PIC18F25/45/55Q43 Silicon Errata and Data Sheet Clarifications

The PIC18F25/45/55Q43 devices you have received conform functionally to the current device data sheet (DS40002170F), except for the anomalies described in this document.

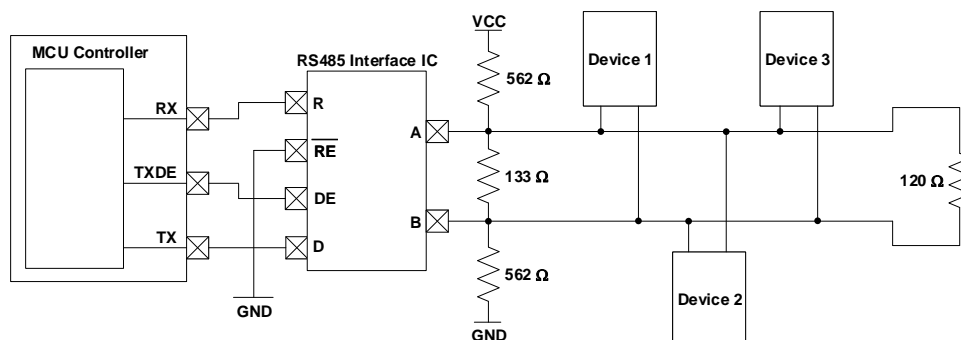
The UART Transmit Drive Enable (TXDE) signal could potentially transition into a low state before the UART STOP bit has been entirely transmitted due to the effects of parasitic capacitance on the TX line. In some applications, this could result in communication being prematurely terminated due to the TXDE bit going low before the STOP bit has had enough time to settle.

To ensure that the STOP bit settles into its final logic state before the TXDE signal transitions low, a biasing circuit can be implemented. A biasing circuit allows the TX line to either be driven high or low, rather than being left in a floating tri-state mode where prolonged rise or fall times could lead to communication being disrupted. This bias circuit should only be implemented on one end of the serial bus, and a termination resistor should be used on the other end. The figure below shows an example of a bias circuit that can be used to achieve this.

Please note that the resistor values used in this circuit are recommendations and that the actual resistor values required may vary based on the application.
